October 9<sup>th</sup>, 2024

Re: **La Foret Certification Letter  
El Paso County, Colorado**

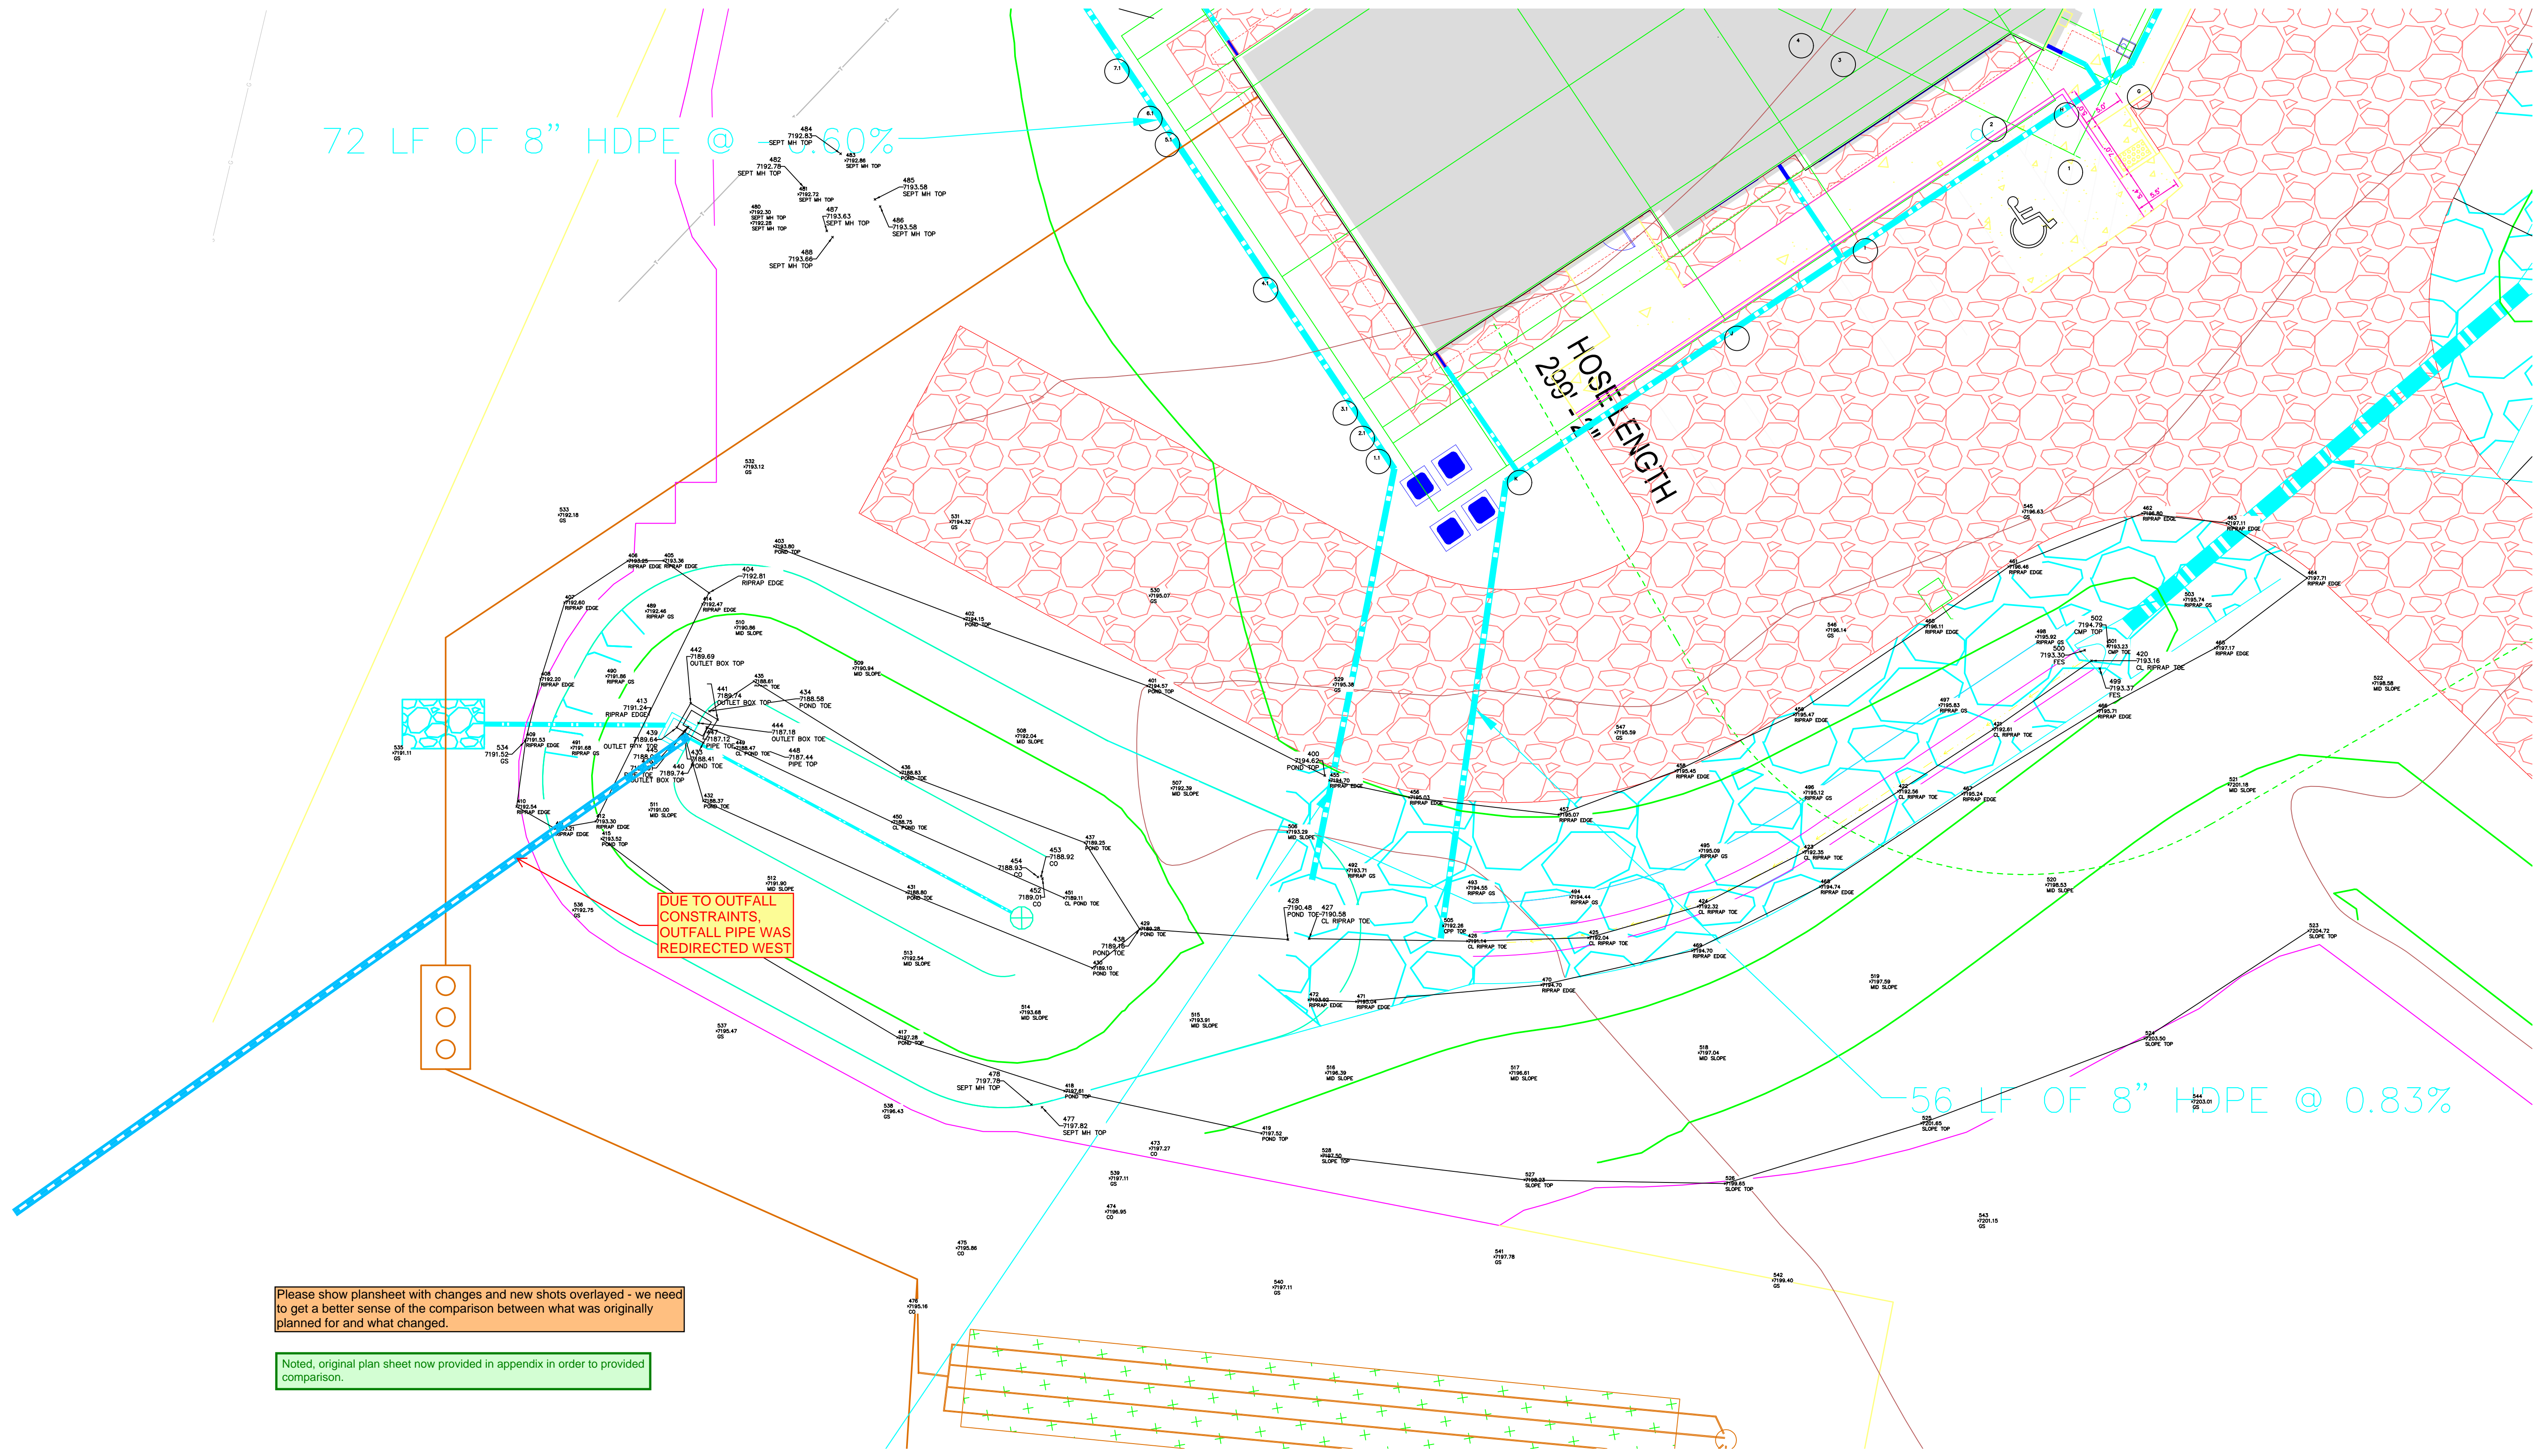
DUE TO OUTFALL CONSTRAINTS,  
OUTFALL PIPE WAS  
REDIRECTED WEST

Please show plansheet with changes and new shots overlaid - we need to get a better sense of the comparison between what was originally planned for and what changed.

Noted, original plan sheet now provided in appendix in order to provided comparison.

DETENTION BASIN STAGE-STORAGE TABLE BUILDER

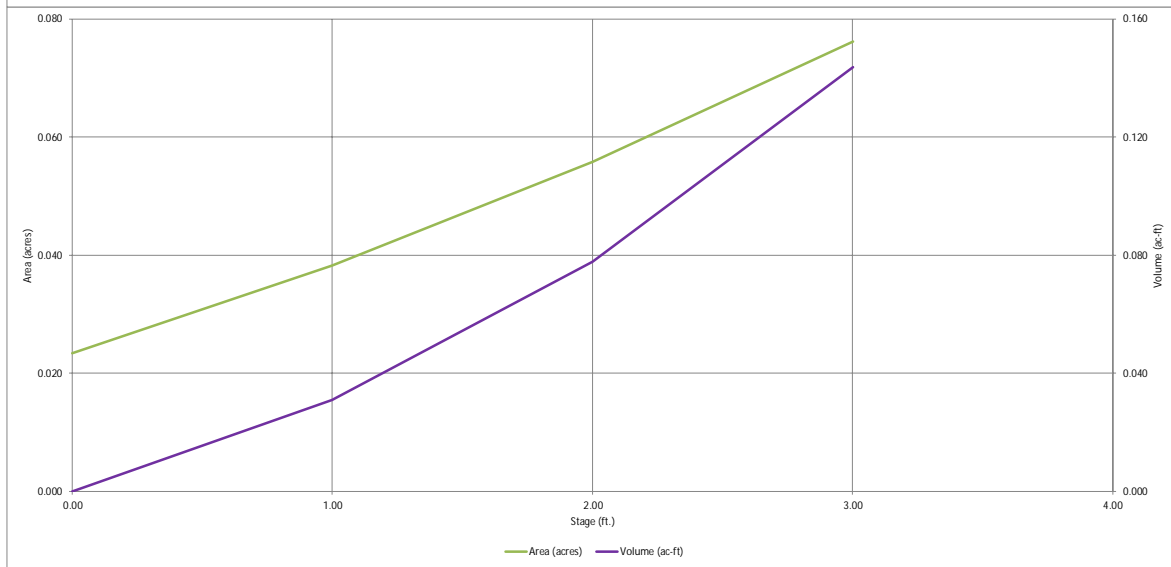
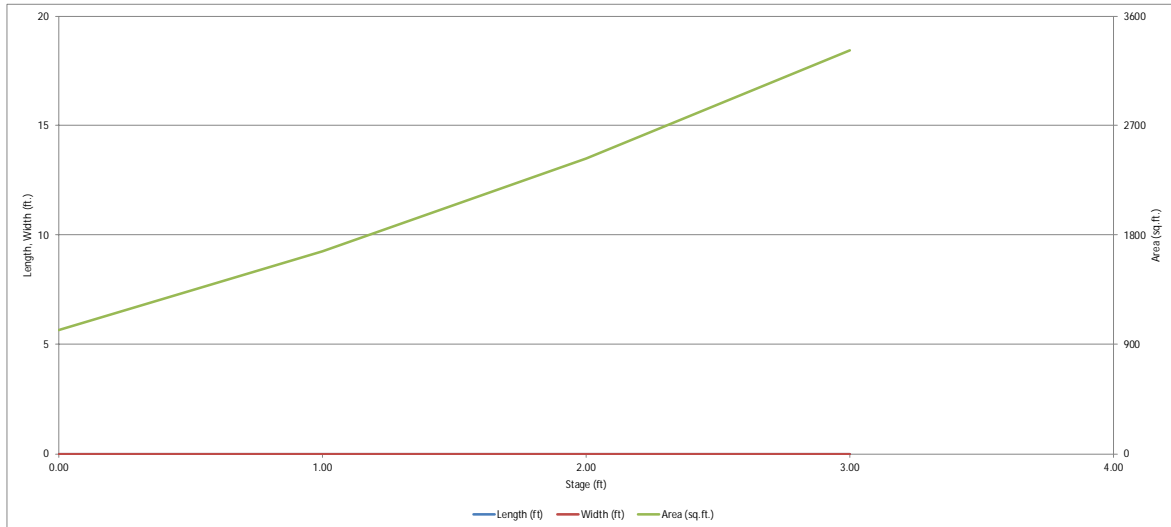
Please include the full MHFD-Detention Spreadsheet so drain times can be confirmed. Please update the MHFD-Detention Spreadsheet with the updated as-built information (pond elevations, spillway length, orifice hole elevations, etc.) to confirm that the pond is functioning as intended. The updated Spreadsheet should be attached to the Pond Certification Letter. If some items haven't change keep that as-is from the design calcs.

This spreadsheet is the revised UD Detention spreadsheet with updated as-built information. The revised spreadsheet confirms the drain times and that the rg is functioning as intended. The Original spreadsheet, as found in the approved FDR, has been provided in the appendix as well for comparison.
